Applicant:	Hacker et al.	Examiner:	M.O. Savage
Serial No.:	09/800,413	Group Art Unit:	1723
Filed:	03/06/2001	Docket No.:	758.924US01
Title:	LIQUID FILTER HAVING INTERCHANGEABLE SPIN-ON CANISTER FILTER AND FILTER CARTRIDGE, AND METHODS

APPELLANT'S BRIEF ON APPEAL

Nr. 236421

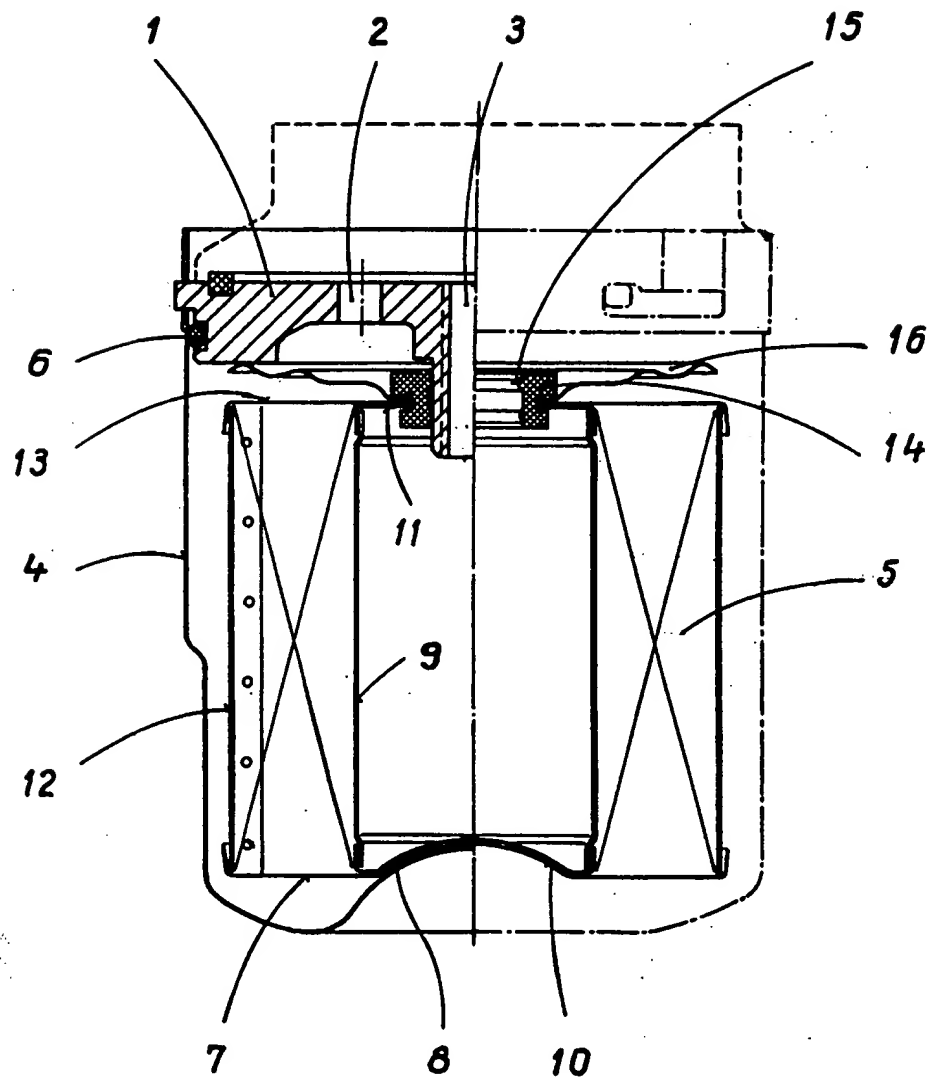
a filter head 1 having a center tube (e.g., defining port 3) defining an end, an outer tube (e.g., carrying seal 16 [sic 6]), a first liquid flow port 2, a second liquid flow port 3, the outer tube circumscribing the

center tube, the outer tube defining an end, an outer tube end port at the end at the end, an outer tube flow passageway extending between and in fluid communication with the first liquid flow port 2, the center tube defining a center tube flow passageway and a center tube end port, the center tube flow passageway extending between and in fluid communication with the second liquid flow port 3,

The Examiner has taken the same structure shown in the Austrian patent and has asserted that this same structure corresponds to different and separate limitations in the claim. For example, the center tube is interpreted as the structure defining port 3; the second liquid flow port is defined as port 3; the center tube flow passageway is interpreted as extending between and in fluid communication with the second liquid flow port 3. The Austrian patent cannot be fairly interpreted to disclose that the center tube flow passageway (shown at 3) extends between and is in fluid communication with the second liquid flow port, which is also reference numeral 3. The Austrian patent does not disclose these limitations as claimed. Applicants request reversal of the rejection for at least this reason.

As admitted in the Office Action, the Austrian patent does not disclose a threaded region on the outer tube of the structure considered by the Examiner to be the filter head; and does not disclose a threaded region on the filter connected to the outer tube of the filter head. Instead, there is a bayonet and pin type of connection shown in the Austrian patent. The filter head in the Austrian patent does not have threads along the outer wall, and does not have threads on the filter.

Nr. 236421

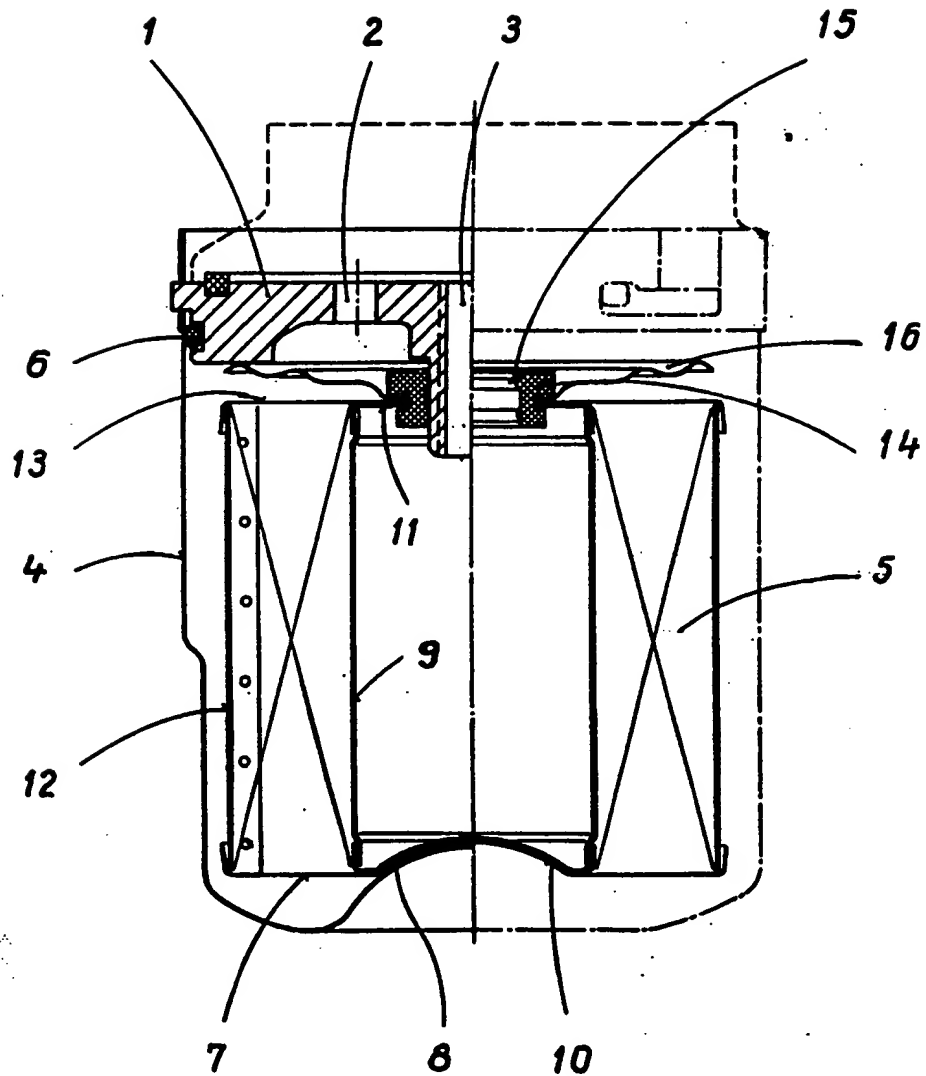
'421 discloses a bayonet connection between an outer region of the outer tube and the filter but fails to specify the filter as having a threaded region 16 threadably engaged to an outer tube threaded region of the filter head. Mules discloses that a bayonet connection and a threaded connection between the outer surface of an outer tube of a filter head and the inner surface of filter are known alternatives (see lines 38-45 of col. 4). It would have been obvious to have modified the '421 filter so as to have included the threaded connection as suggested by Mules in order to provide a known alternative connection for the filter. '421 and Mules fail to specify the limitation of the threaded connection having a cross sectional thickness no greater than 10 mm. Gullett discloses an analogous filter housing having a threaded region 22 having a cross sectional

thickness no greater than 10 mm (see lines 12-17 of col. 4) and suggests that such a dimension provides the required strength for the threaded connection of an oil filter housing. It would have been obvious to have modified the combination suggested by '421 and Mules so as to have included a threaded region having a cross sectional thickness as suggested by Gullett in order to provide the required strength for the threaded connection of an oil filter housing.
